UNITED STATES PATENT AND TRADEMARK OFFICE

APPLICATION NO.	FILING DATE	FIRST NAMED INVENTOR	ATTORNEY DOCKET NO.	CONFIRMATION NO.
10/666,606	09/17/2003	Yu-Chih Cheng	3304.2.86	8554
21552	7590	03/20/2006	EXAMINER	
MADSON & AUSTIN GATEWAY TOWER WEST SUITE 900 15 WEST SOUTH TEMPLE SALT LAKE CITY, UT 84101				NGUYEN, KEVIN M
		ART UNIT		PAPER NUMBER
		2674		
DATE MAILED: 03/20/2006

Office Action Summary	Application No.	Applicant(s)	
	10/666,606	CHENG, YU-CHIH	
	Examiner	Art Unit	
	Kevin M. Nguyen	2674

DETAILED ACTION

FIG.4

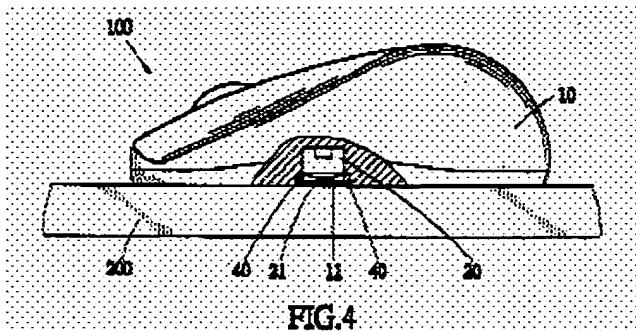
3. As to claim 1, Kuan teaches a third embodiment of a dual mode input device [100, Fig. 4] performing data input function by a moving action in a first mode [a forward moving mode, Fig. 4, col. 4, lines 27-30], and performing data input function by a manipulating operation on an input element in a second mode [a rearward moving mode, Fig. 6, col. 4, lines 27-30], comprising:

a main body [a body 10, Fig. 4] having a sensor window [an optical sensing 20, fig. 5] on a surface thereof [a surface of a bottom of the mouse 100, col. 4, line 11-12], said sensor window moving relative to a plane [a mouse pad 200, fig. 4] to perform data input function in said first mode [the forward moving mode, see Fig. 4, col. 3, lines 40-57];

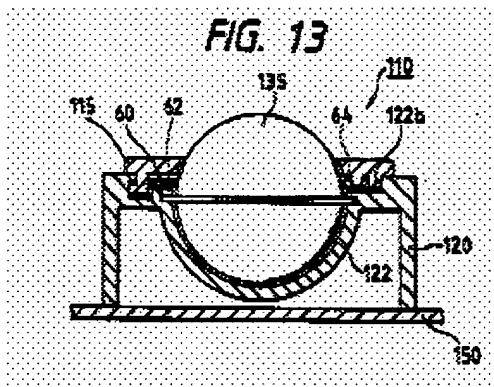
However, Tooi teaches related trackball coordinate data inputting device which includes said supporting member [a ball holder 60, Fig. 13]. It would have been obvious to recognize that the ball holder 60 in Fig. 13 substantially has a hollow semi-spherical shape.

It would have been obvious to a person of ordinary skill in the art at the time the invention was made to modify the Kuan's panel 30 corresponding to the supporting member as claimed to become the ball holder 60 substantially having a hollow semi-spherical shape as taught by Tsoi in order to achieve the benefit of the ball holder may be replaced by other means (Tsoi, col. 10, lines 66-67), and the track ball unit can be operated with high efficiency and with high accuracy (Tsoi, col. 10, lines 65-66), because this would improve the operability and the detecting accuracy of the input device (Tsoi, col. 3, lines 41-42), while improving the assembling efficiency and manufacturing cost of the input device (Tsoi, col. 3, lines 46-47).

FIG. 4

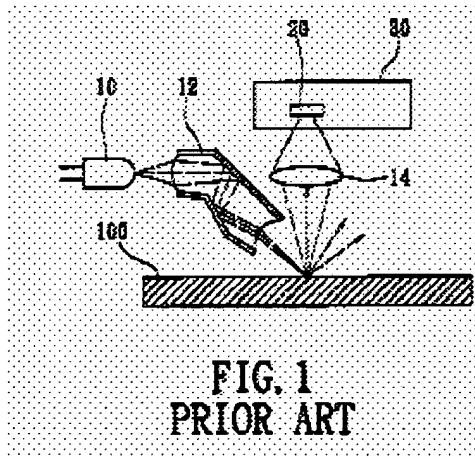
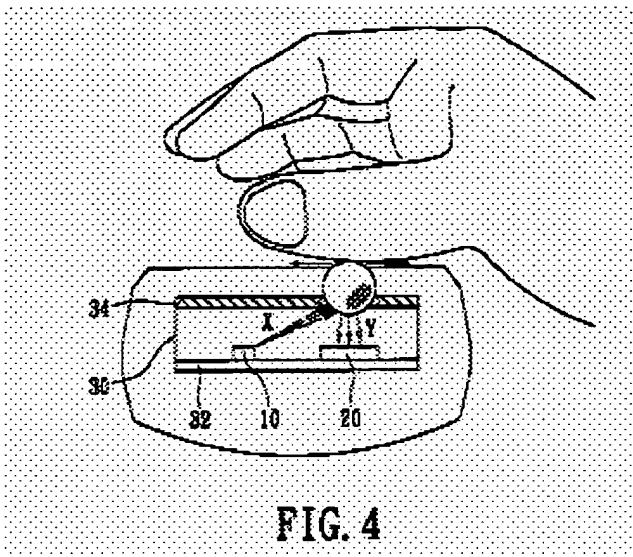
mouse device (paragraph 9) which includes and an optical trackball (40, fig. 4) in the second mode (see paragraph 23).

It would have been obvious to a person of ordinary skill in the art at the time the invention was made to modify the Kuan's conventional optical mouse in the first mode including the optical track ball (40) in the second mode taught by Sun et al, because this would provide the optical mouse with higher light transmission efficiency and low cost (see Sun et al, paragraph 7).

As to claim 21, Sun et al further teach wherein said input element is a trackball (40, Fig. 3) and rotated and rotated to move relative to said sensor window (20, Fig. 4) to perform data function in said second mode [see paragraphs 21 and 23].

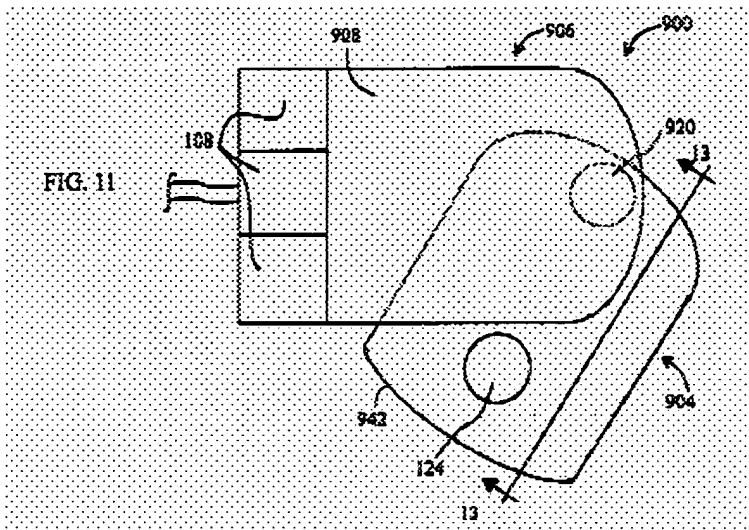
The present invention is directed to a dual mode input device (see claim 1). The closest prior art, Wang (US 6,580420) discloses an input device 100 can be used either as a mouse or as a trackball (see fig. 1, col. 9, lines 15-17). Wang further discloses the input device 900 having a ball-carrying member 904 which is pivotally attached to an outer housing 906 (see fig. 11, col. 9, lines 50-52).

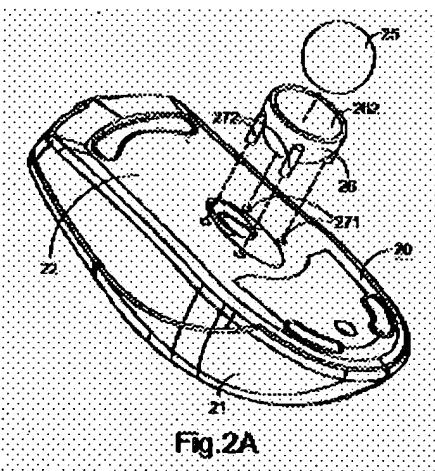
The improvement of the dual mode input device comprising: wherein said securing member comprises: a plurality of positioning holes arranged on said surface of said main body around said sensor window; and a plurality of pins coupled said supporting member and having positions corresponding to said plurality of positioning holes, respectively, said plurality of pins being inserted into said plurality of positioning holes to secure said supporting member onto said surface of said main body over said sensor window in said second mode (see Cheng, Fig. 2A).

Fig.4B

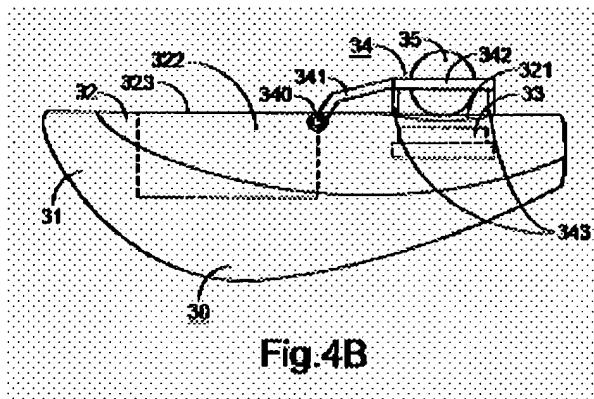
Or the improvement of the dual mode input device comprising: wherein said supporting member is pivotally connected to said surface of said main body, and pivoted to hide inside said main body in said first mode and sit over said sensor window in said second mode (see Cheng, Fig. 4B). This patentable distinction is included in all independent claim 1.
